FURNISHING CHARTS, TBLS, AND FIGS IN REF TO
THE INTERIM CHANGE TO THE TECH SPEC AS
REQUESTED.....

PLANT NAME: **ST LUCIE #1**

Re: St. Lucie Unit 1
 Docket No. 50-335
 Proposed Amendment to
Facility Operating License DPR-67

Figure 2.1-1 REACTOR CORE THERMAL MARGIN SAFETY LIMIT - FOUR REACTOR COOLANT PUMPS OPERATING

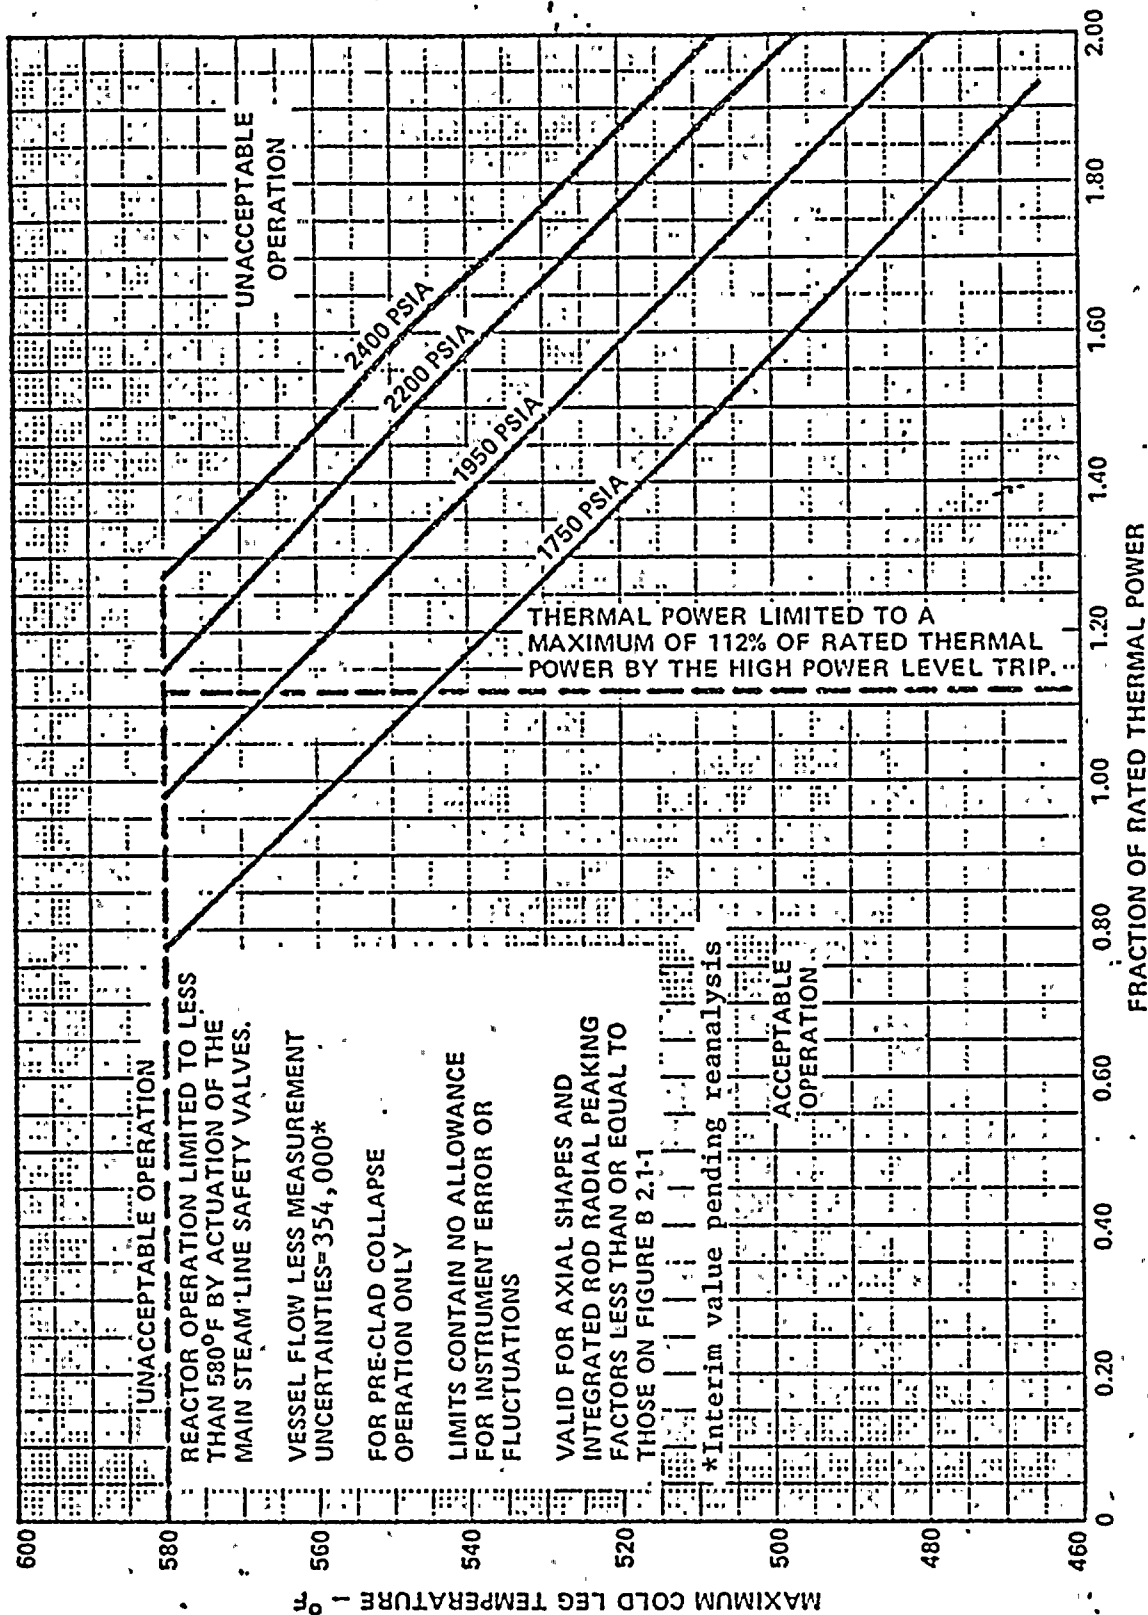
VESSEL FLOW LESS MEASUREMENT UNCERTAINTIES on Figure 2.1-1 is changed from 370,000 GPM to 354,000 GPM. (Interim change).

Change 370,000 GPM to 354,000 GPM as indicated on Figure 2.1-1.

The present Reactor Core Thermal Margin Safety Limit shown by Figure 2.1-1, page 2-2, represents a locus of points corresponding to a limit of 1.3 DNBR (W-3) for a reactor coolant flow of 370,000 GPM and for the rod radial peaks and axial power distributions shown in Figure B2.1-1, page B2-2. If reactor coolant flow is decreased, there is a corresponding increase in the enthalpy rise across the core. This results in an increase in the quality in the hot channels, and the limit of 1.3 DNBR is reached at a lower value of rod radial peak. The values of rod radial peak indicated on the revised Figure B2.1-1 have been reduced to a factor of 0.95 to accommodate a 5% reduction in the reactor coolant flow. Thus for the revised rod radial peaks, and the axial power distributions in the revised Figure B2.1-1 and for the reduced reactor coolant flow of 354,000 GPM, the Thermal Margin Safety Limit in Figure 2.1-1, page 2-2, continues to represent a locus of points corresponding to a limit of 1.3 DNBR (W-3).

FIGURE 2.2-3

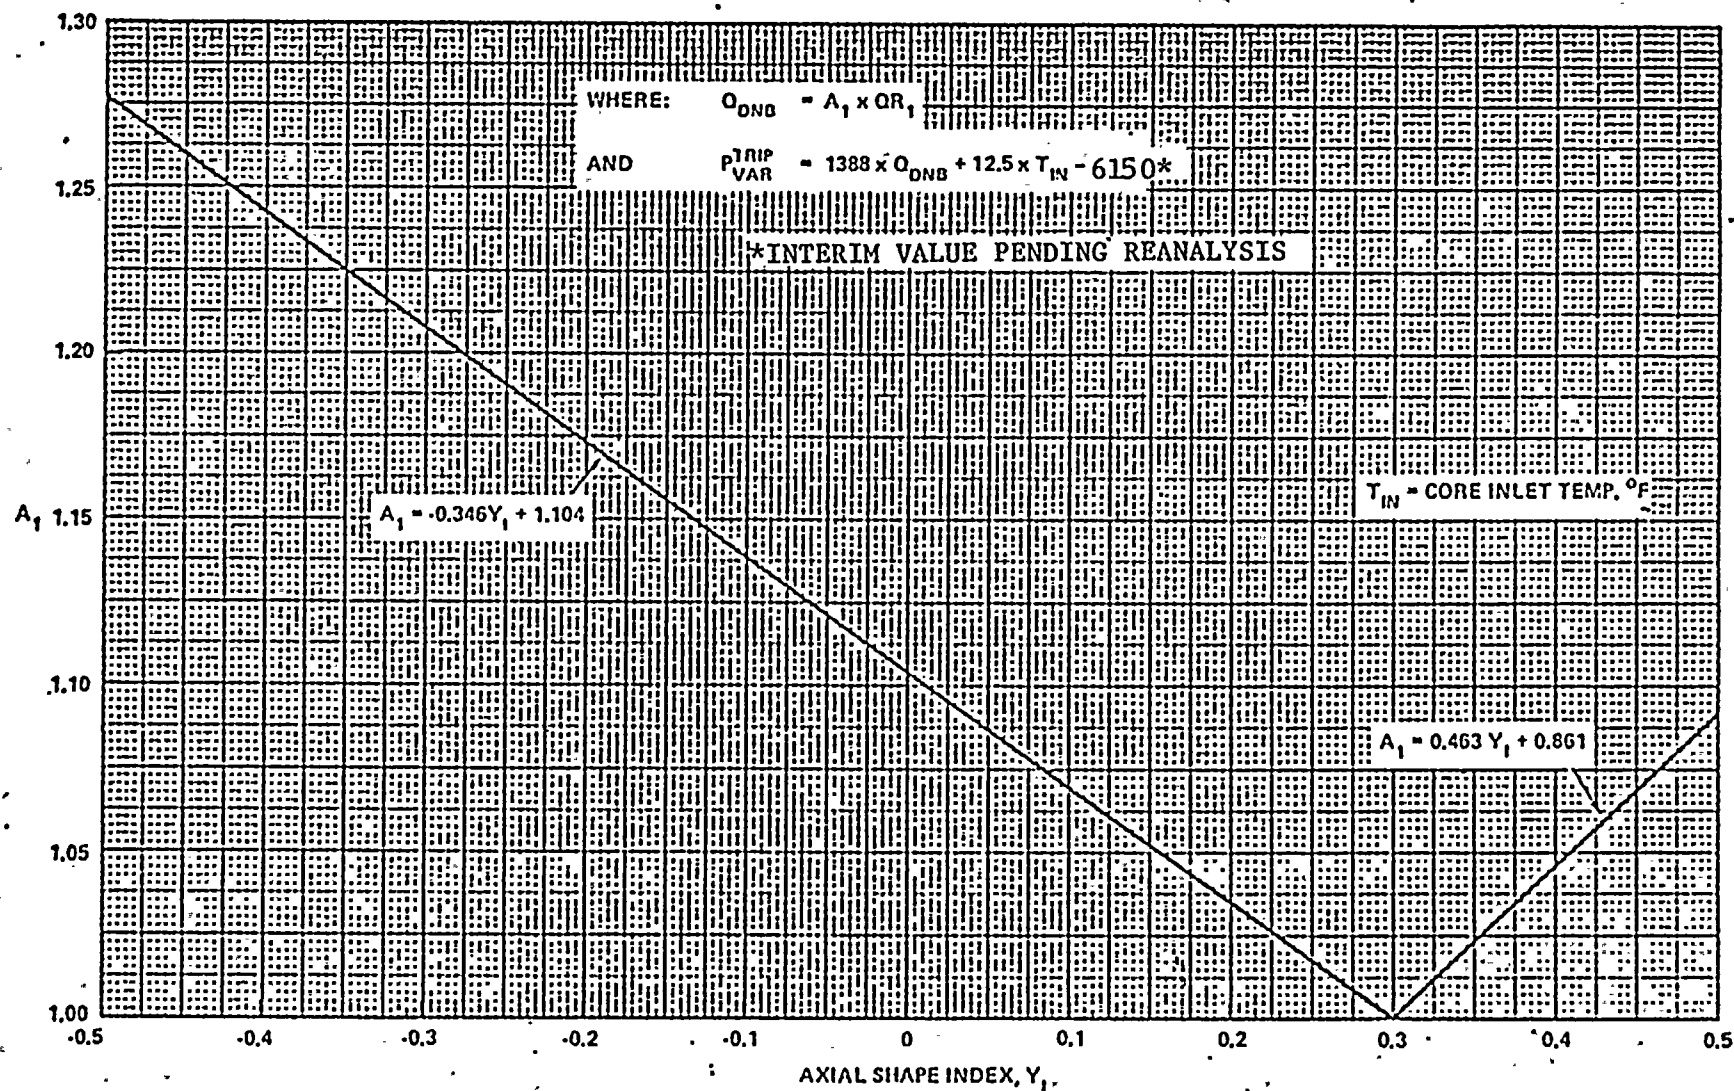
On Figure 2.2-3, the last factor in the P_{VAR}^{TRIP} equation is changed from 6250 to 6150. (Interim change).

Change p_{var}^{trip} equation to read:

$$p_{var}^{trip} = 1388 \times Q_{DNB} + 12.5 \times T_{in} - 6150$$

The Thermal Margin/Low Pressure trip is provided to prevent operation when the DNBR (W-3) is less than 1.30. The available margin to the limit of 1.30 DNBR previously calculated for a wide range of core conditions has been reduced to a factor of 0.95 to accommodate a 5% reduction in the reactor coolant flow. The revised LSSS implement this reduction by modifying the computed value of pressure at which a reactor trip is initiated. This modification is shown in the p_{var}^{trip} equation in the revised Figures 2.2-3 and 2.2-4. The revised thermal margin LSSS provide at least the same margin of safety as that provided with the present LSSS.

FIGURE 2.2-4

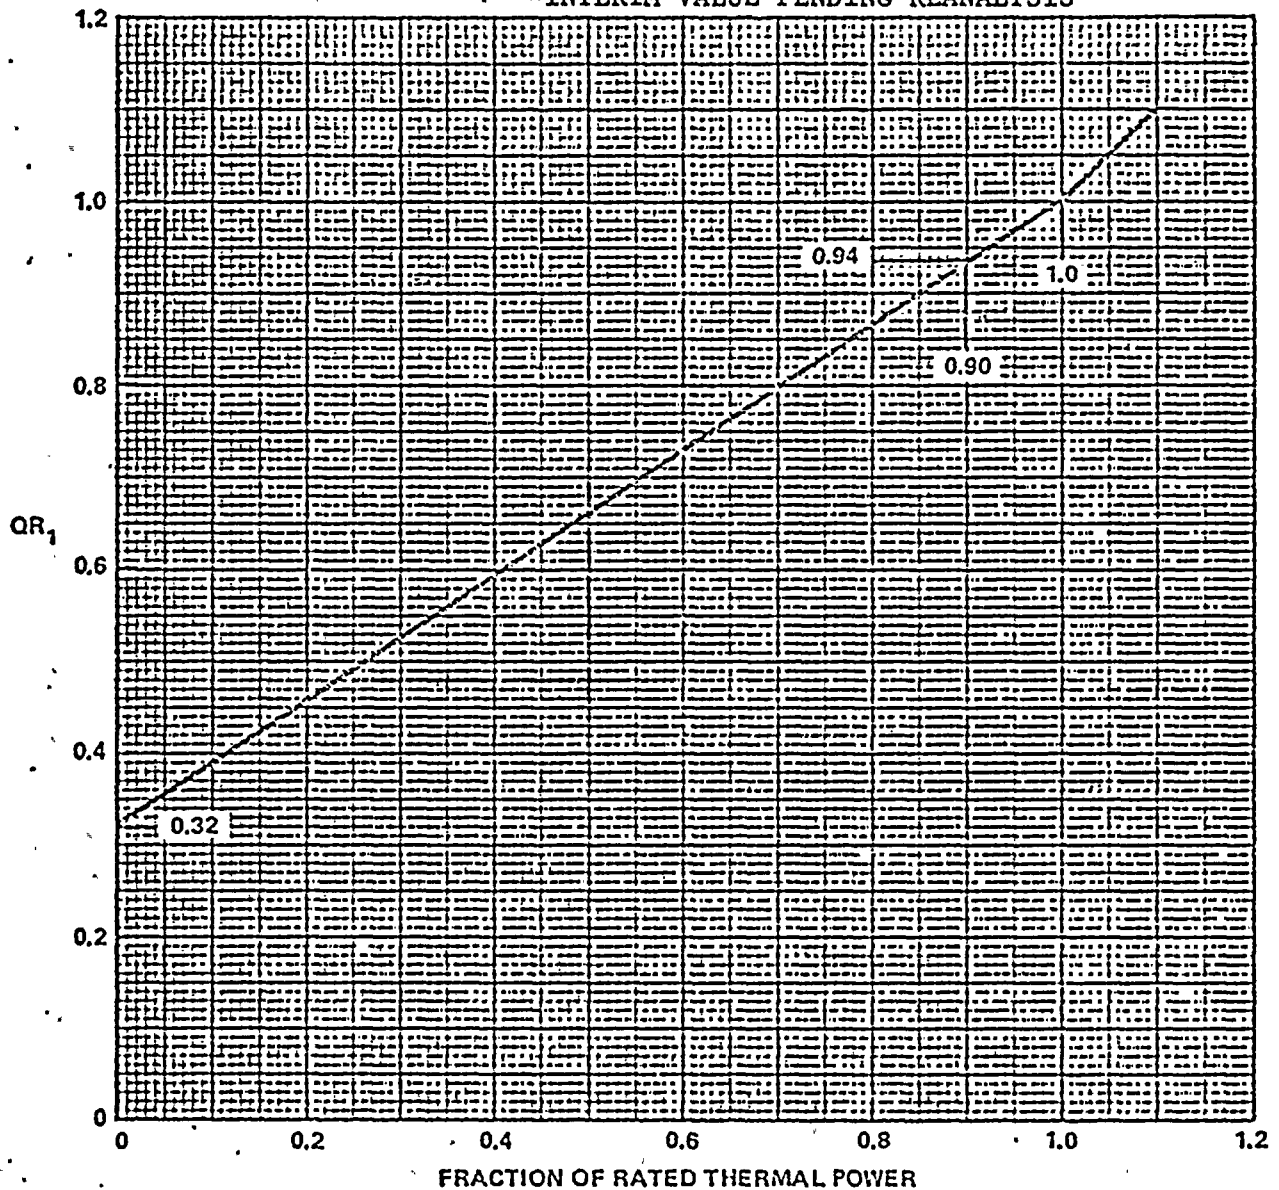
On Figure 2.2-4, the last factor in the P_{VAR}^{TRIP} equation is changed from 6250 to 6150. (Interim change).

Change p_{var}^{trip} equation to read as specified in item 2.c above.

Figure B2.1-1 Axial Power Distribution for Thermal Margin Safety Limits

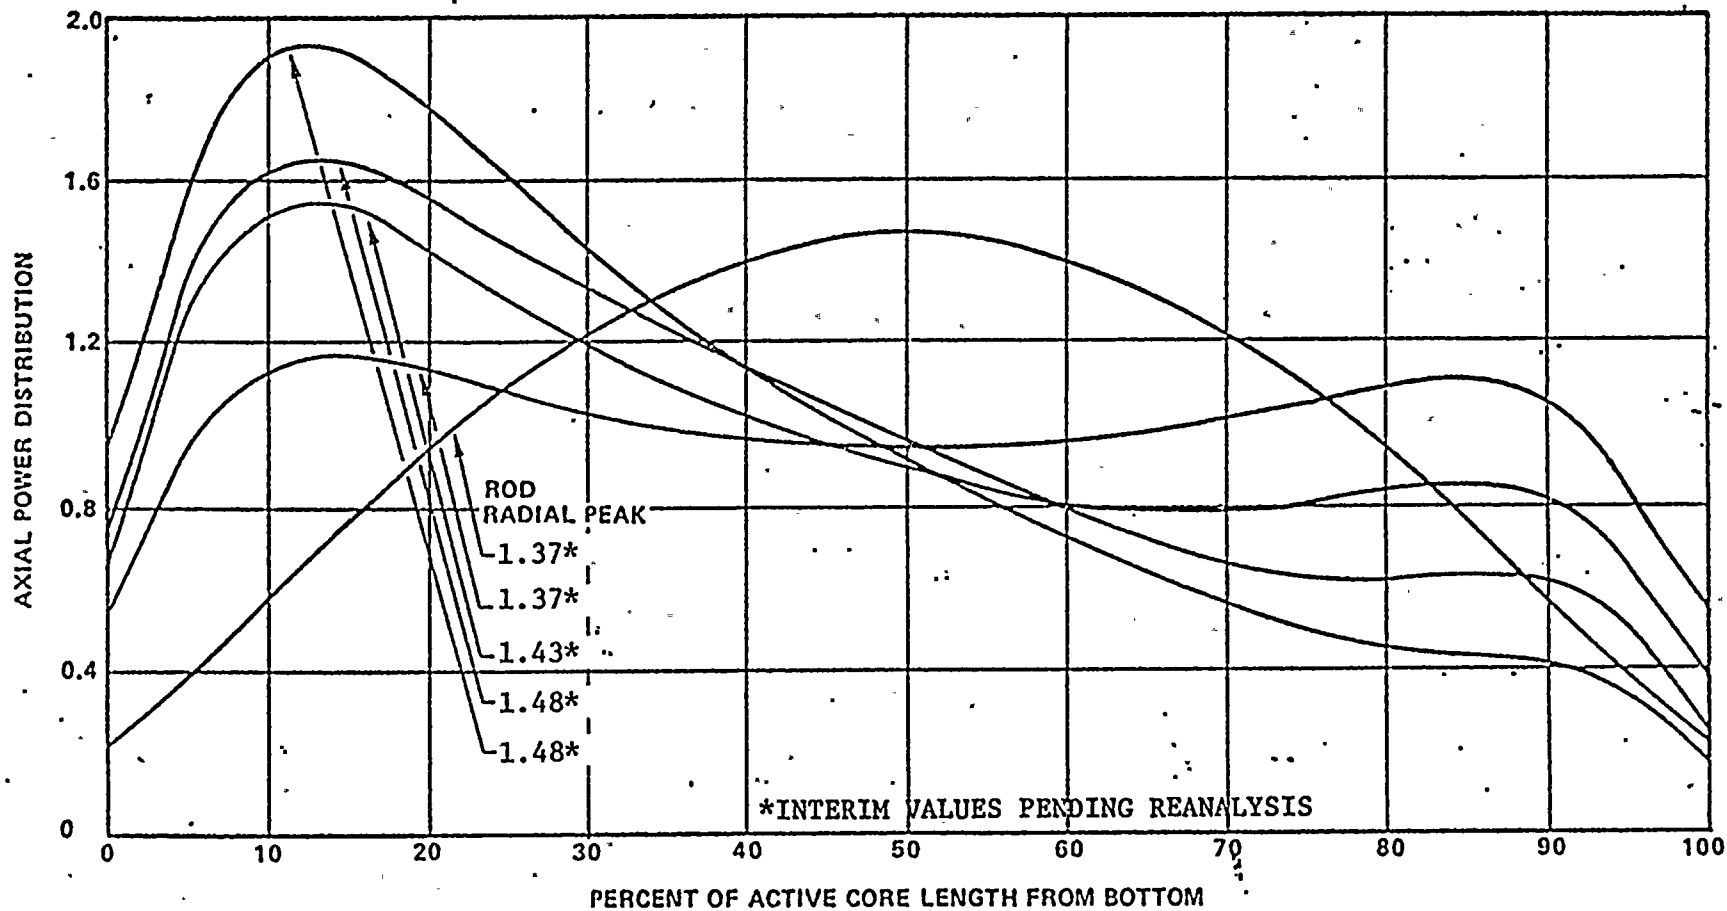
The values of ROD RADIAL PEAK are changed to those indicated on attached Figure B2.1-1. (Interim change).

Change the values of the rod radial peaks to those indicated on Figure B2.1-1.

Figure 3.2-2

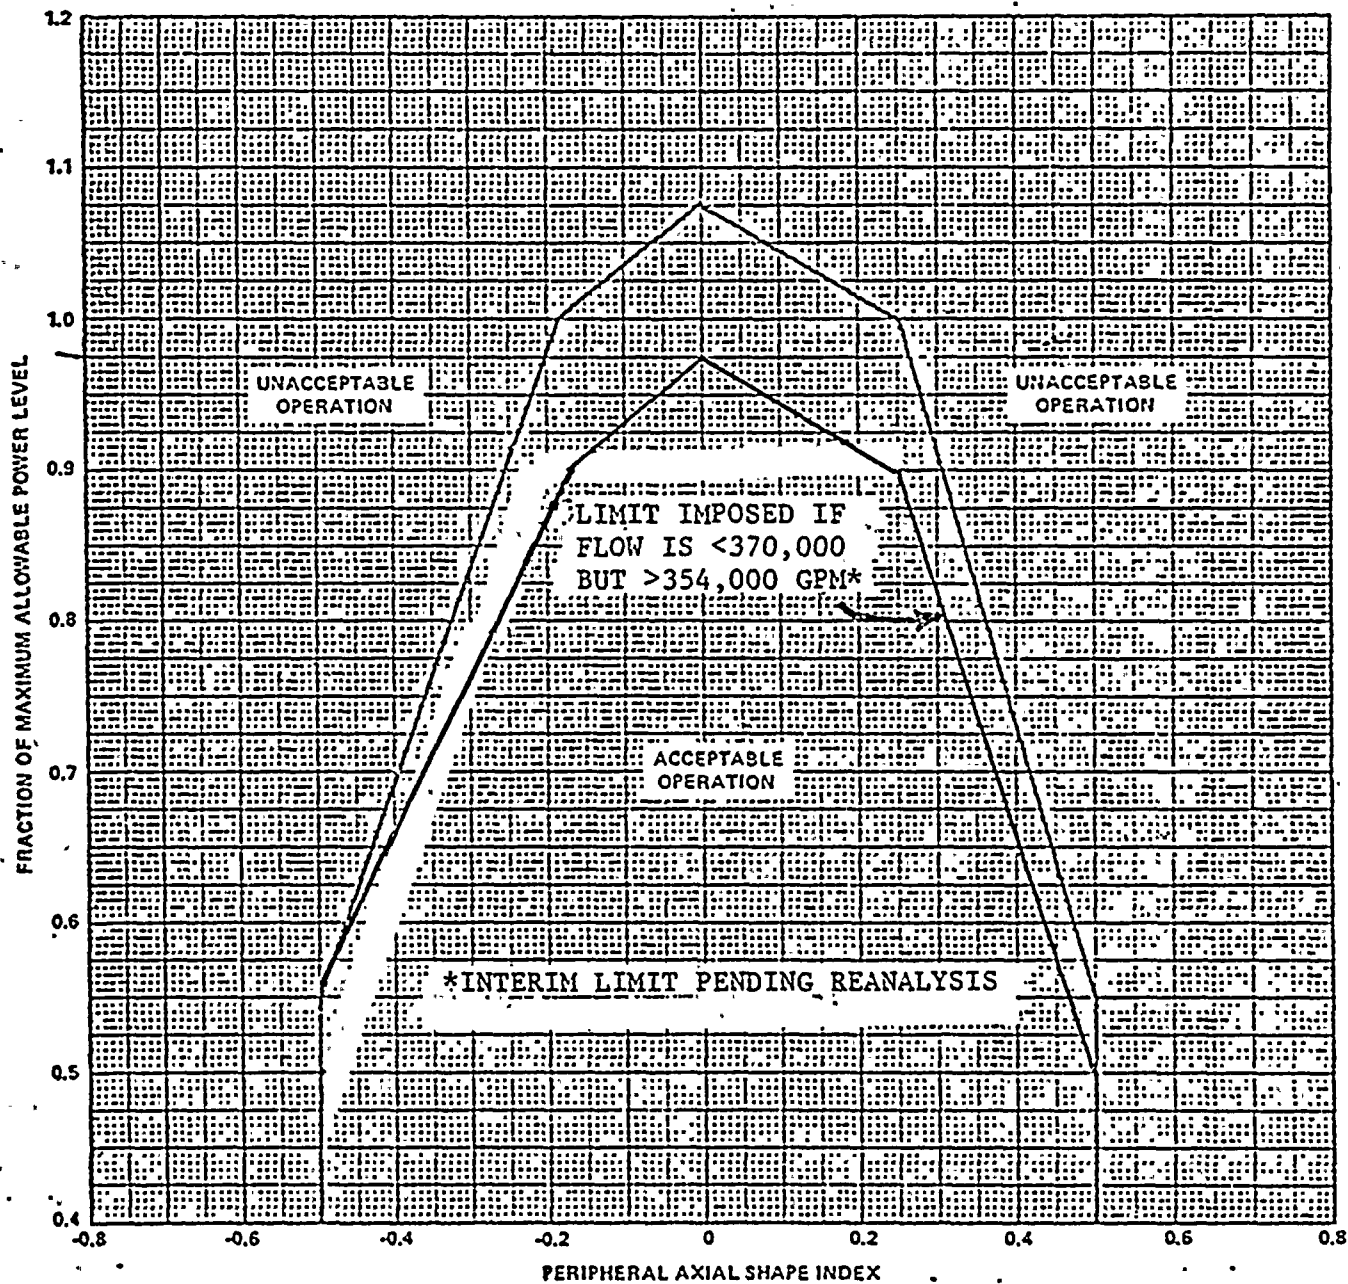
Figure 3.2-2 is revised to reflect a power limitation of 90 per cent pending reanalysis at the 354,000 gpm flow rate. (Interim change).

Change to implement the revised Figure 3.2-2.

Item 3.c. refers to the LCO on axial shape index to maintain the require steady-state operating margin on linear heat rate when the ex-core detectors are used to monitor this limit. Since the limiting value of kw/ft has at present been established by the LOCA analysis, Figure 3.2-2 has been reduced to a factor of 1.10 to accommodate the 5% reduction in reactor coolant flow. The basis for this reduction is provided after item 3.e below.

FIGURE 3.2-4
AXIAL SHAPE INDEX Operating Limits with 4 Reactor Coolant
Pumps Operating

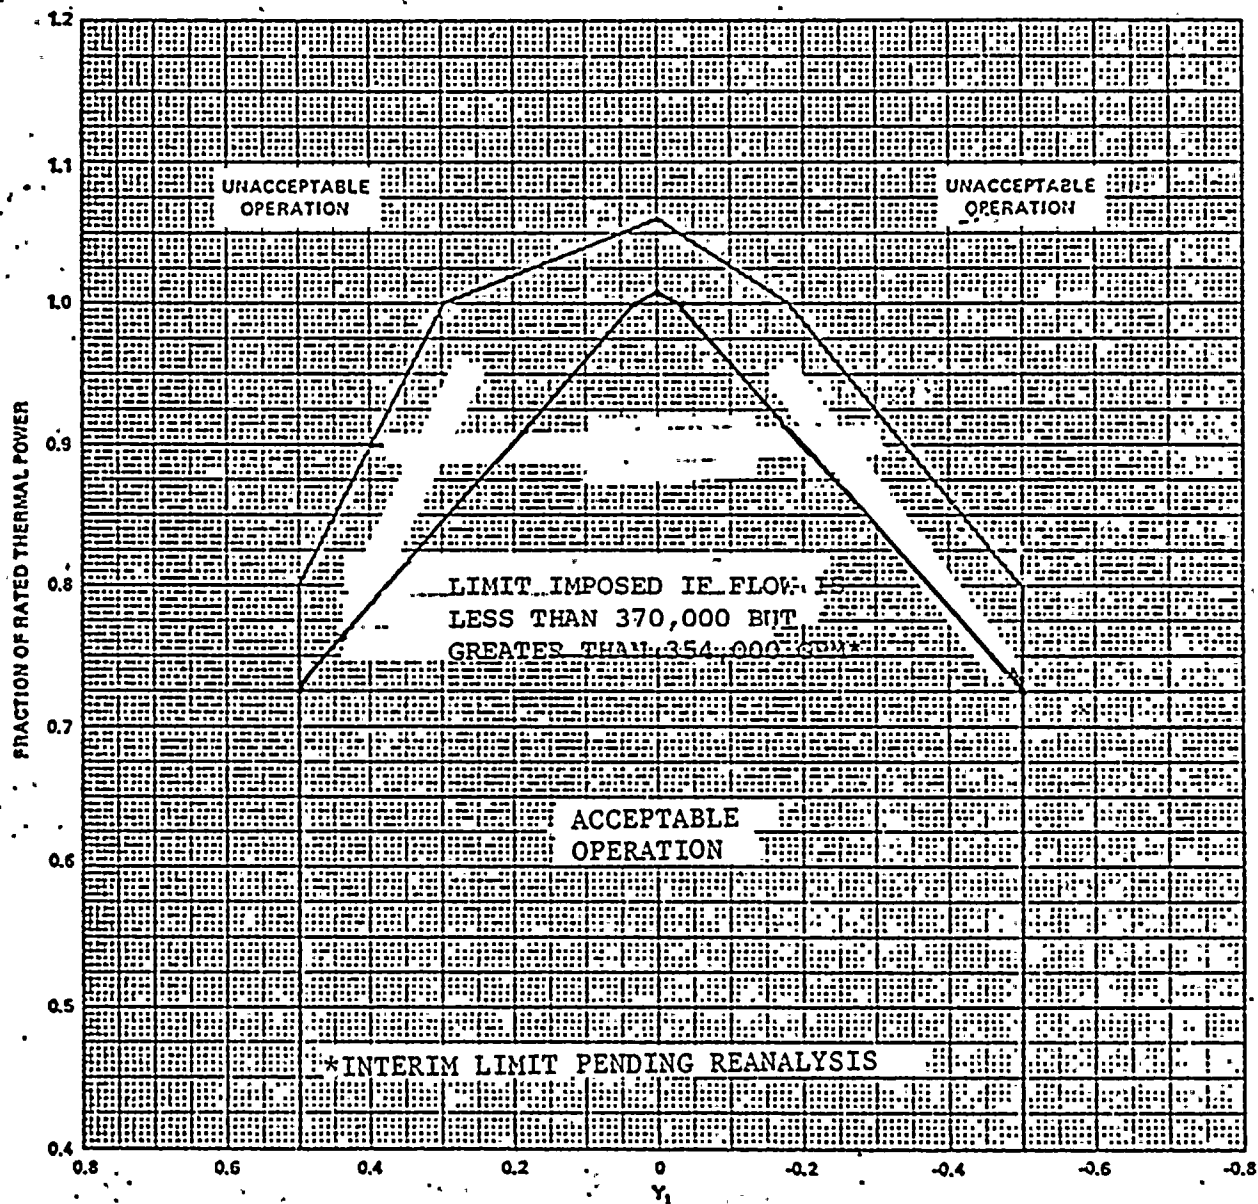
Figure 3.2-4 is revised to reflect a power limitation of 90% pending reanalysis at the 354,000 gpm flow rate. (Interim change).

Change to implement the revised Figure 3.2-4.

Item 3.a. is modified to be consistent with the reduced reactor coolant flow rate. Item 3.b. refers to the Limiting Condition for Operation (LCO) on the axial shape index to maintain the required steady state operating margin to DNB. The available margin to a 1.3 DNBR calculated for a wide range of core conditions was reduced to a factor of 0.95 to accommodate a 5% reduction in reactor coolant flow. The revised LCO was established consistent with this reduction. The transient analyses of the design basis LCO and the initial assumptions in the FSAR have been reviewed, and it was concluded that the revised LCO in Figure 3.2-4 provides at least the same margin of safety as that provided with the present LCO.
